You will find enclosed a copy of Service Bulletin S07LN regarding the routing of the alternator power cable on your Blue Bird All American model bus(es).

Alternator Cable Routing

MODELS AFFECTED: 2007 A3FE All American

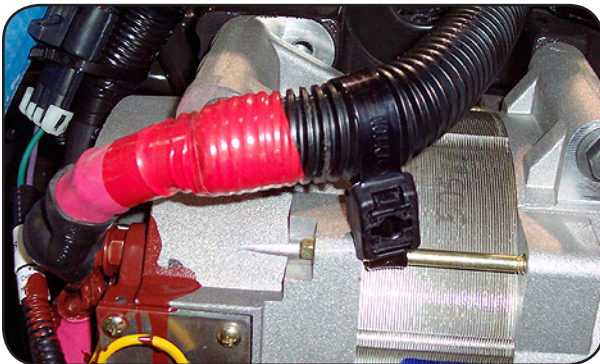
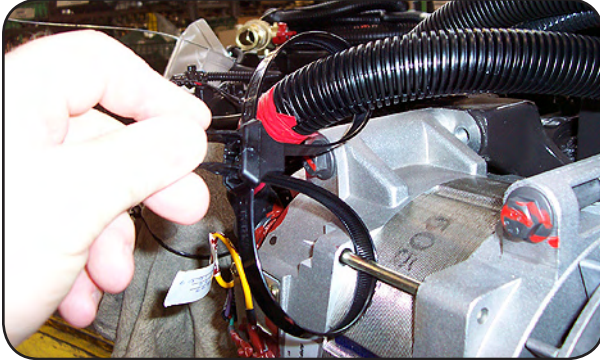
The positive battery cable leading from the rear of the alternator to the Power Distribution Unit (PDU) may contact the charge air cooler tube.

Before: Cable contacting CAC tube.

4.1 With the terminal nut which secures the battery power cable to the back of the alternator loose, press the cable toward the right side of the alternator. Secure in place using the dual cable tie assembly looped around the cable and the bolt shaft of the alternator.

4.2 Tighten the connector nut to 17-22 ft lb.

After: Cable secured to prevent contact with CAC tube.
